Summary for DRH12-00319

Hawkin's Company / Brian Vaughn requests Design Review approval to construct four, single-story retail/commercial buildings on property located at 300 S. Capitol Boulevard in a C-5DDC (Central Business with Downtown Design Review and Capitol Boulevard overlay) zone.

Planning Division Staff Report

File Number	DRH12-00319
Applicant	Hawkins Company's / Bryan Vaughn
Property Address	300 South Capitol Boulevard
Public Hearing Date	December 12, 2012
Heard by	Design Review Committee
Analyst	Sarah Schafer

capitol blvd. + front st. site plan
 1/16"=1'-0"

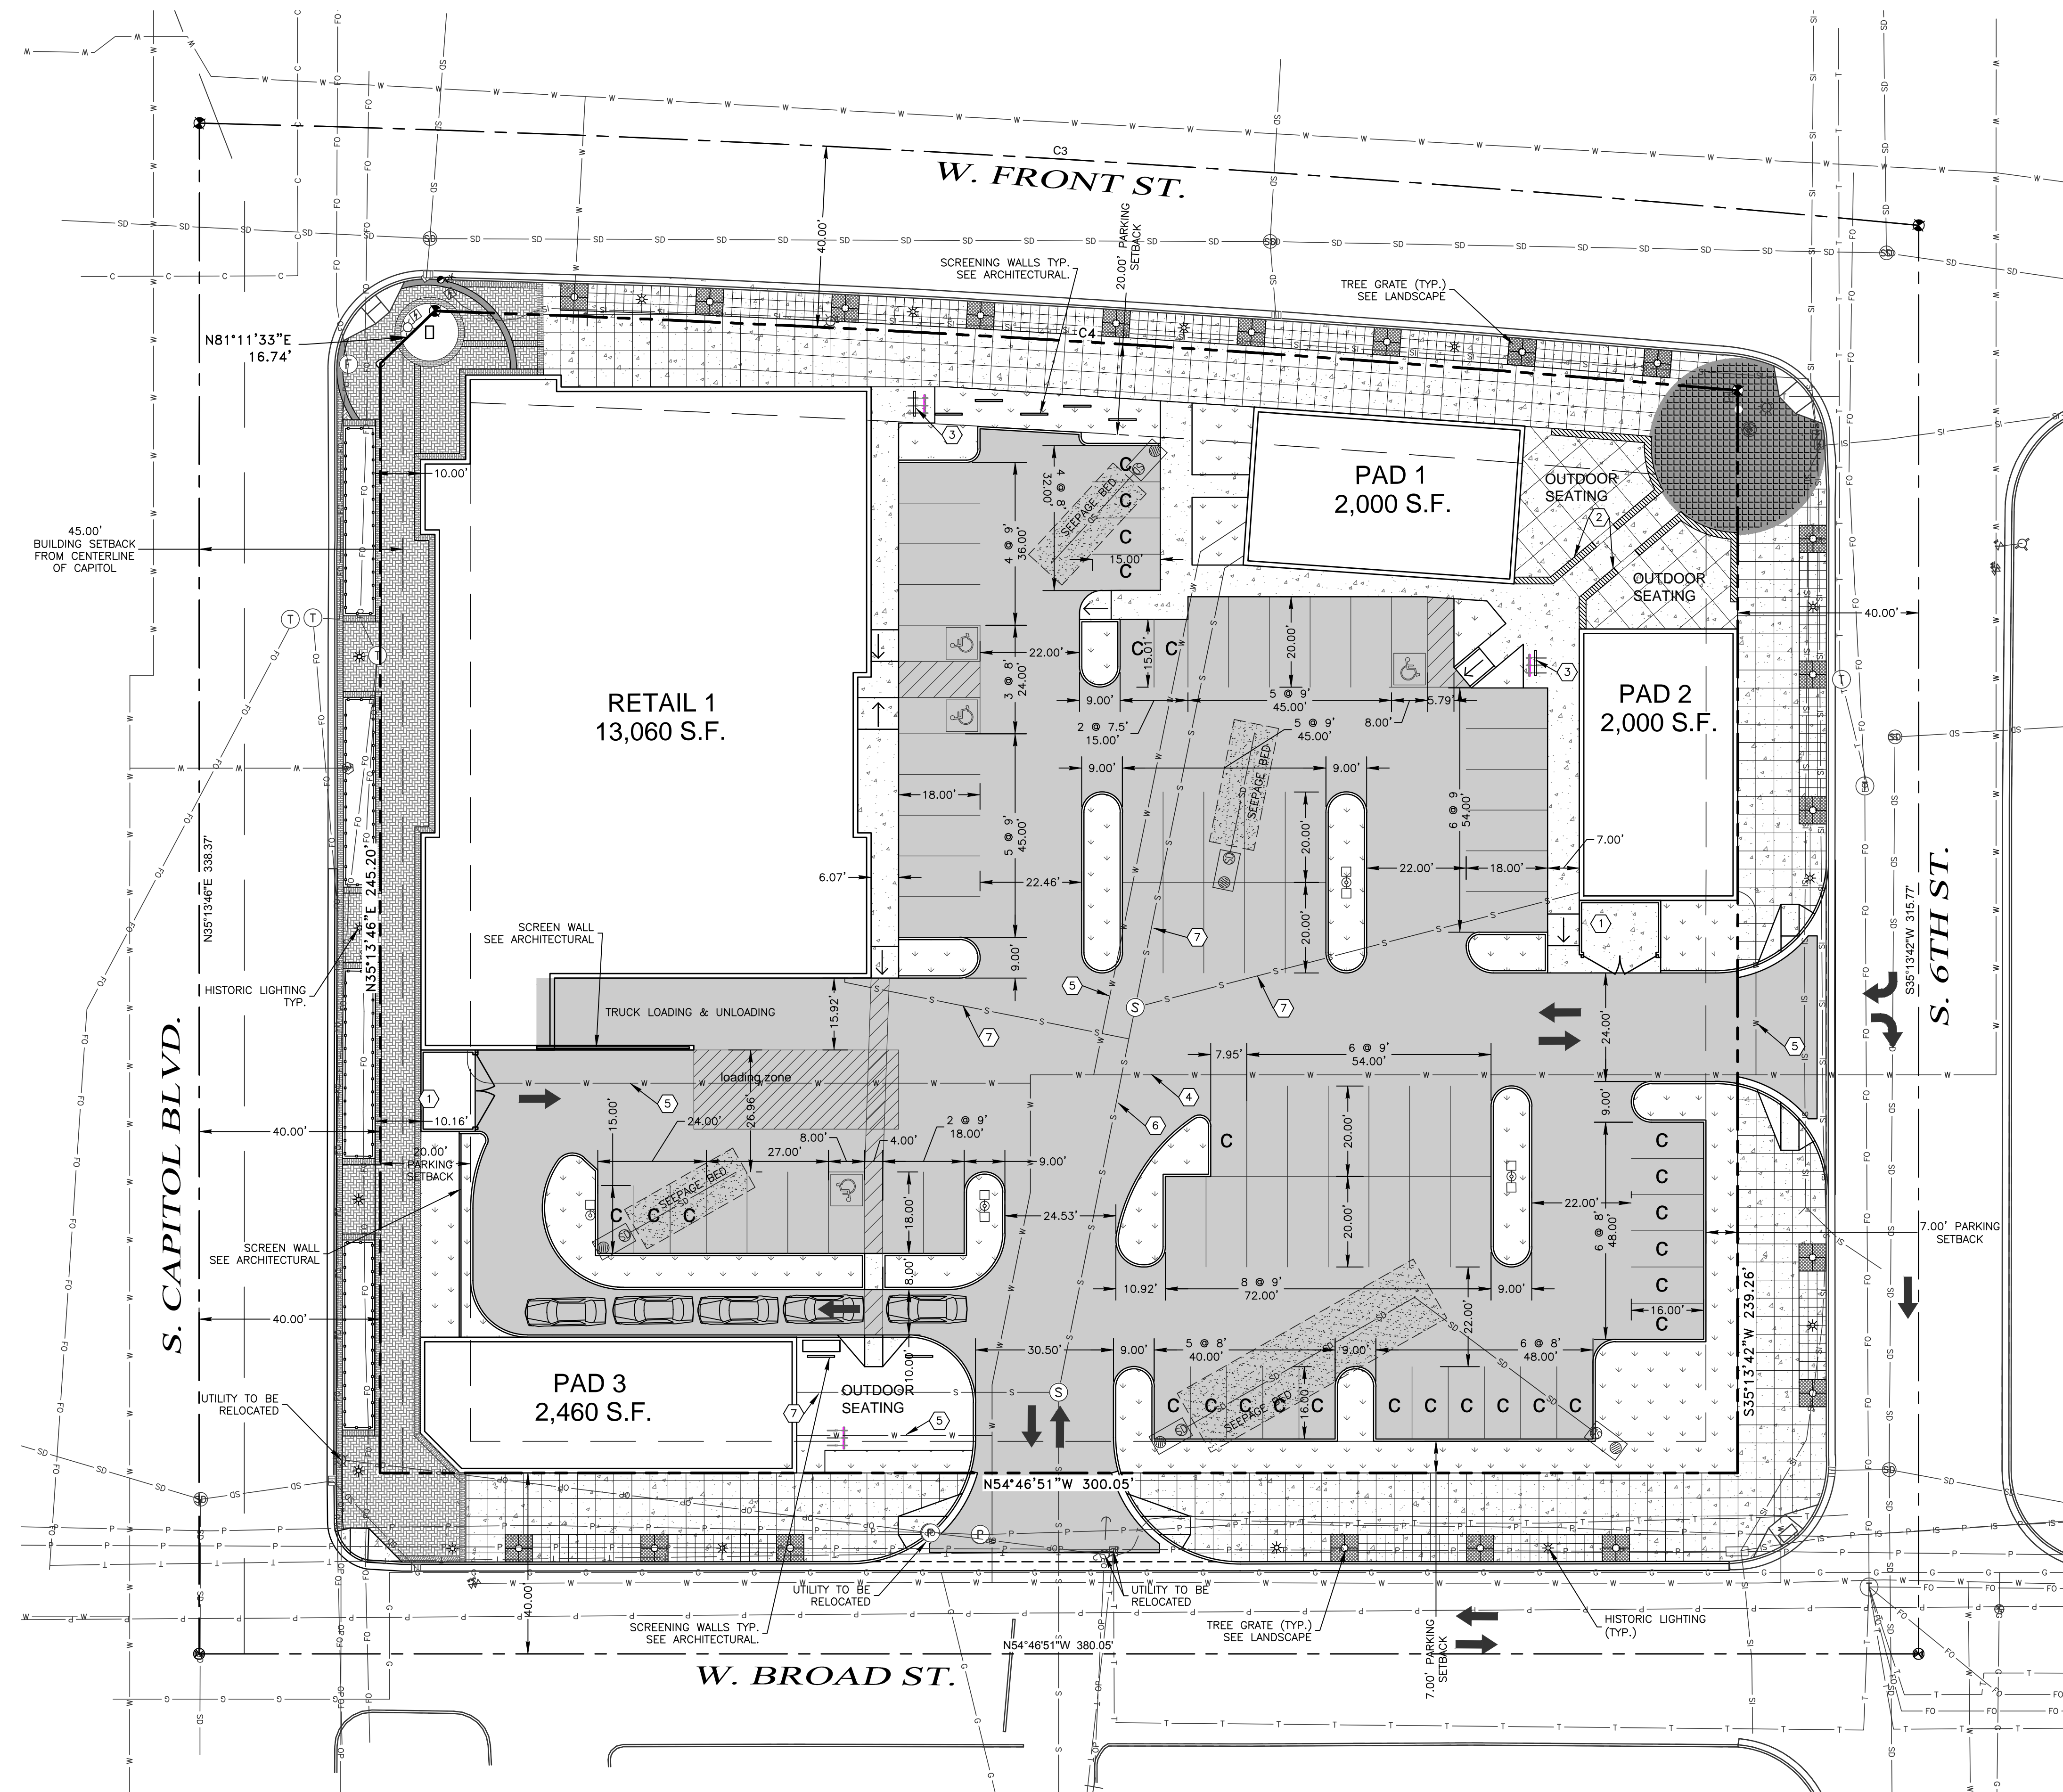
Site lighting has been shown on the plans. Staff has placed a condition of approval requiring the relocation of the lighting out of the planter islands.

The lighting is currently shown as being located within the parking lot planters. Per the above referenced ordinance section they will need to be moved to within the parking field.

- a. All site lighting shall be removed from required landscape planters and relocated into the parking field.
 - b. Clear pedestrian pathways shall be designated on the site between the buildings through the parking field. The pathways shall be designated through a change in paving material, color and/or pattern. Specifically a walkway shall be delineated along the west side of the access on Broad Street to the front of Retail 1 and on the north side of the access from 6th Street along the back of the row of parking to the front of Retail 1.

landscape plan

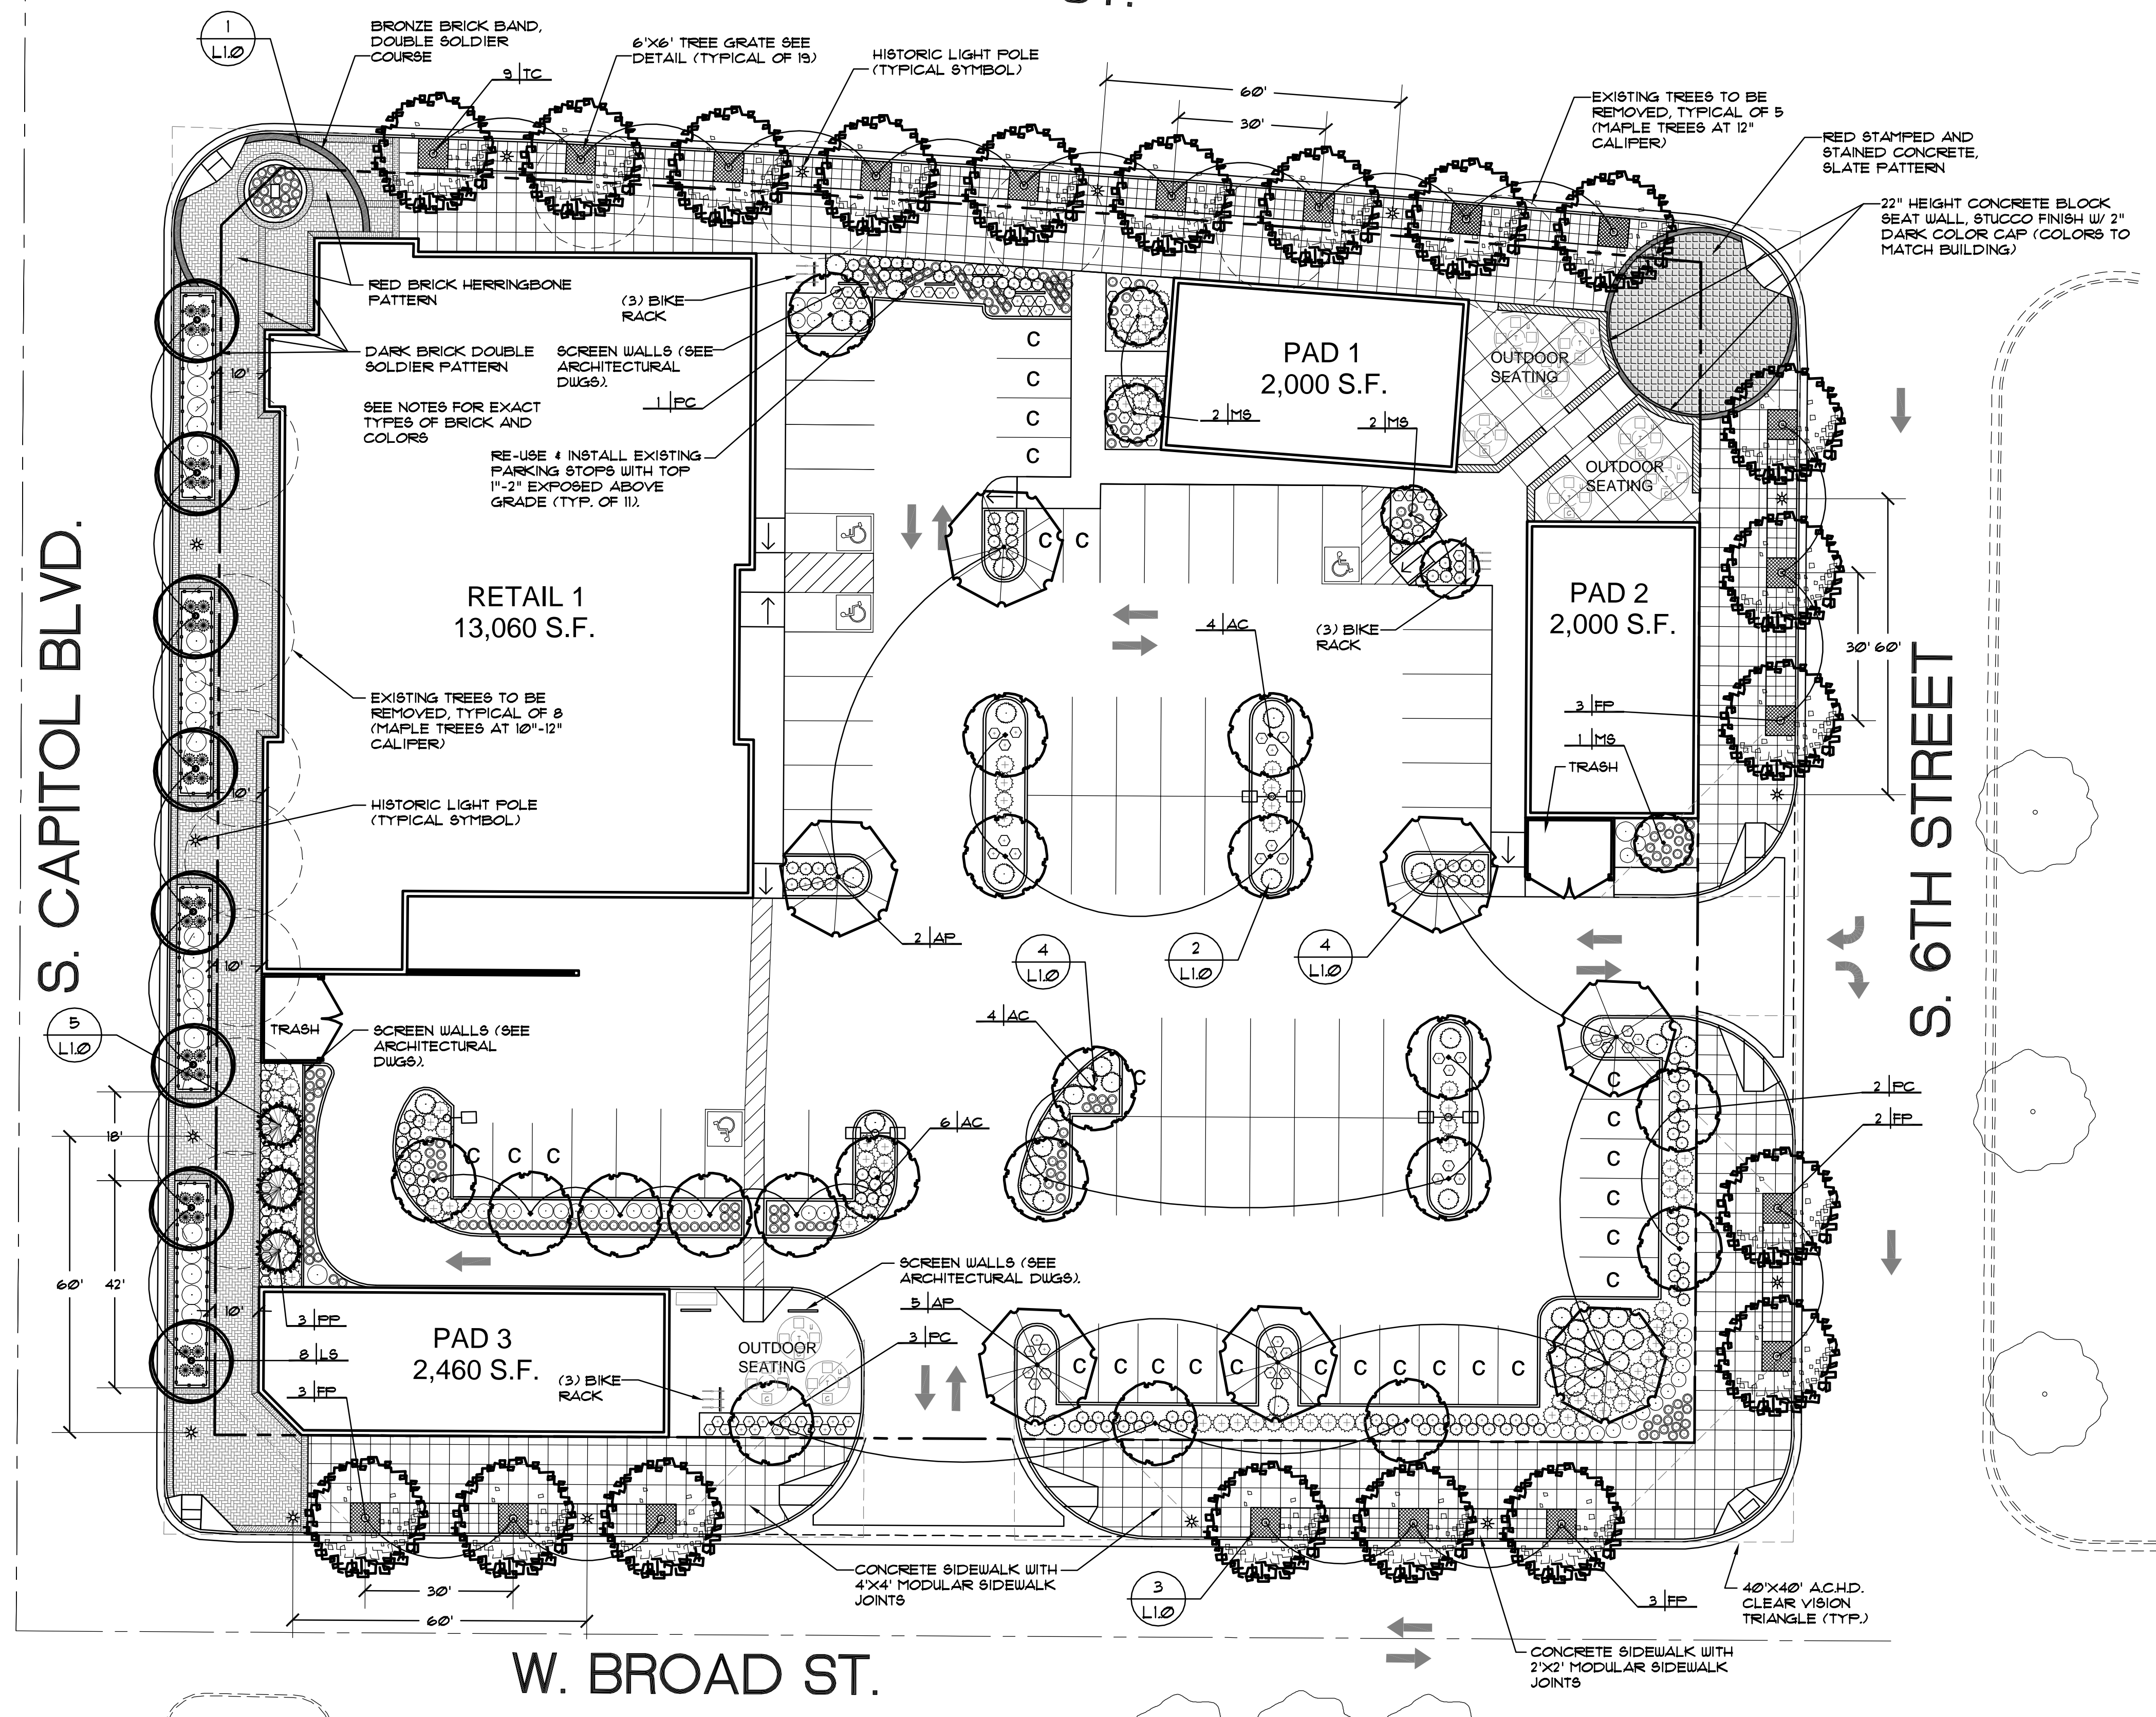
The proposal is for two Emerald Sentinel Sweetgum trees, six Merlot Flower Carpet Rose and eight Blue Salvia or Thumbelina English Lavender. As these plantings don't meet the adopted requirement a condition of approval has been suggested that the plans be changed to comply with the ordinance.

Community Forestry has also suggested to staff that the use of the Norway Maple within the parking field should be changed. The columnar tree will provide little shade benefit to the parking area. They have suggested the Shademaster Honey Locust.

- e. The landscape planters along Capitol Boulevard shall be modified to reflect the landscape vegetation required as part of the ordinance, specifically the shrub rose and Baltic Ivy.

- q. The trees within the parking lot planters shall be Shademaster Honey Locust (both the Norway Maple and Parkway Maple shall be switched except for where in conflict with the drive through roof canopy).
- r. Provide continuous canopy along the Capitol Boulevard side of Retail 1.

a3.12

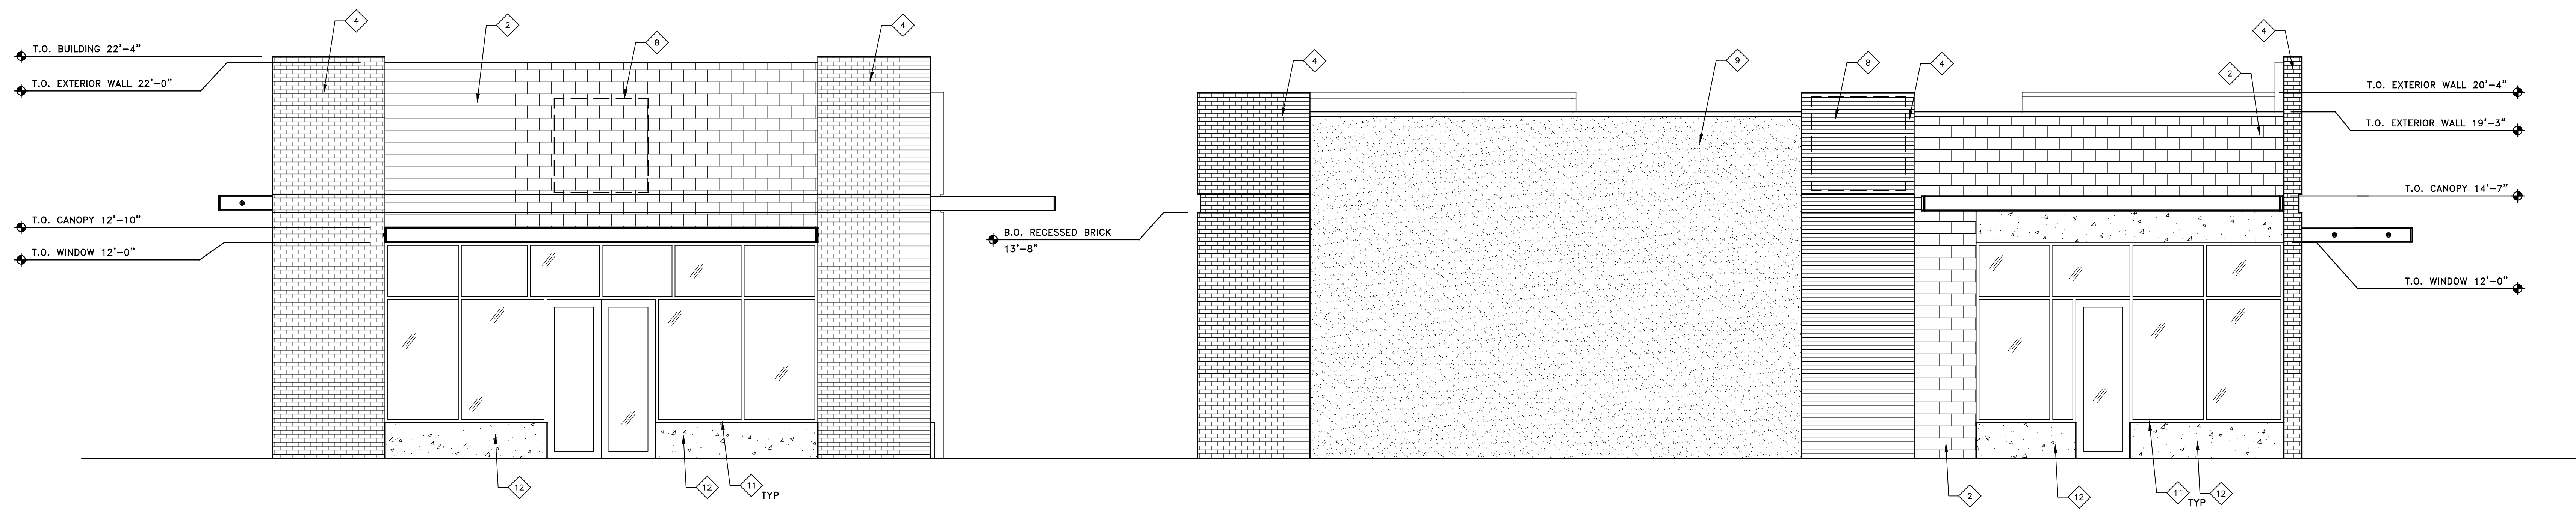
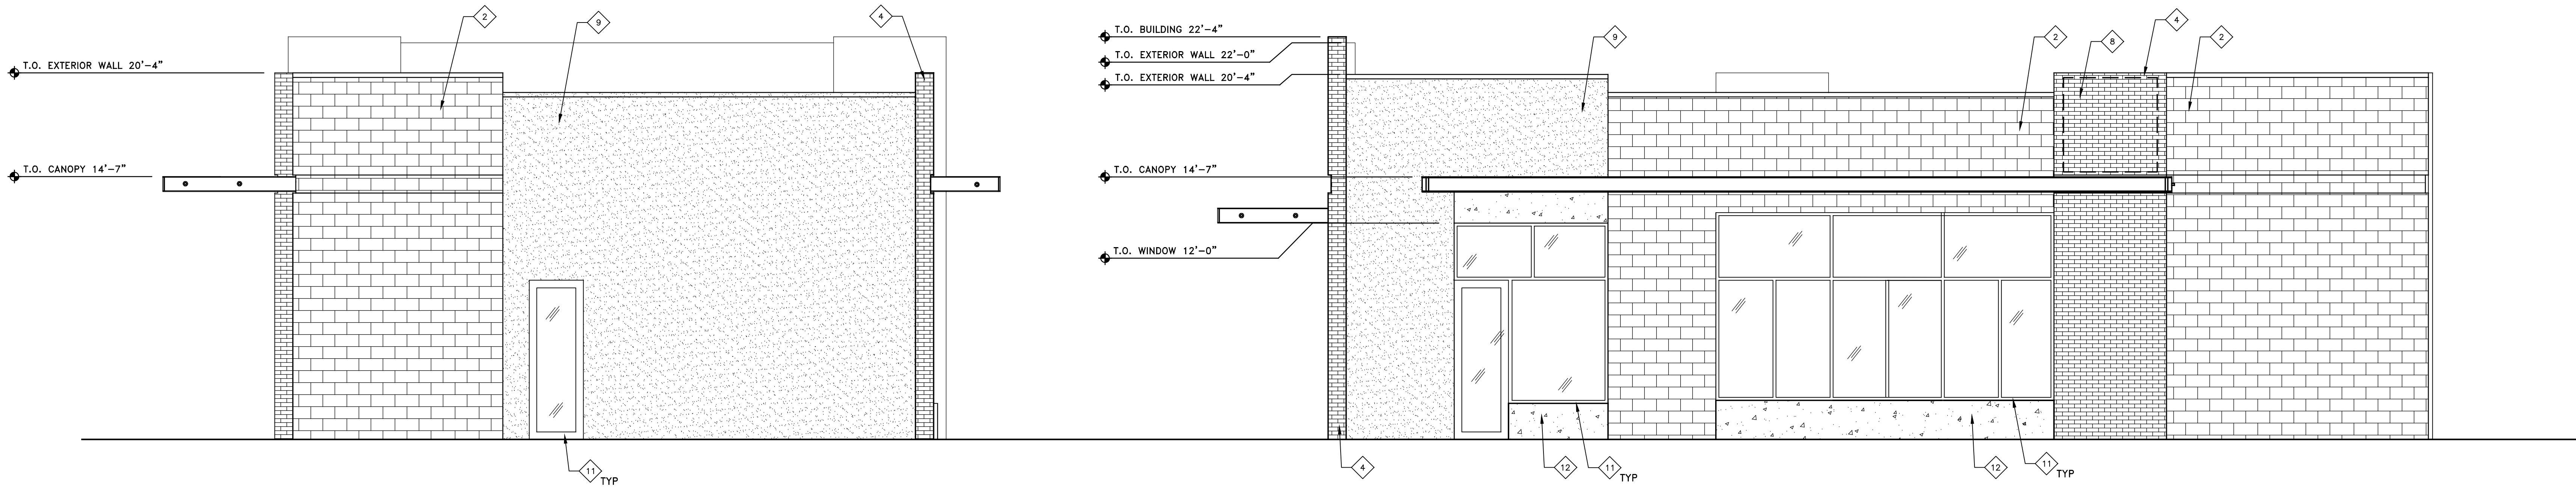
The south elevation which faces the parking area has storefront on the east end of the elevation but also contains a fairly significant expanse of blank wall with no planters to allow for vegetation to soften it. Staff suggests a condition of approval which will require some additional design interest on this elevation.

- n. Provide additional design interest on the south elevation of Pad 1.
 - o. Provide additional design interest on the west elevation of Pad 2.
 - p. Consolidate the entry locations on Pad 3 to a single entry at the corner.
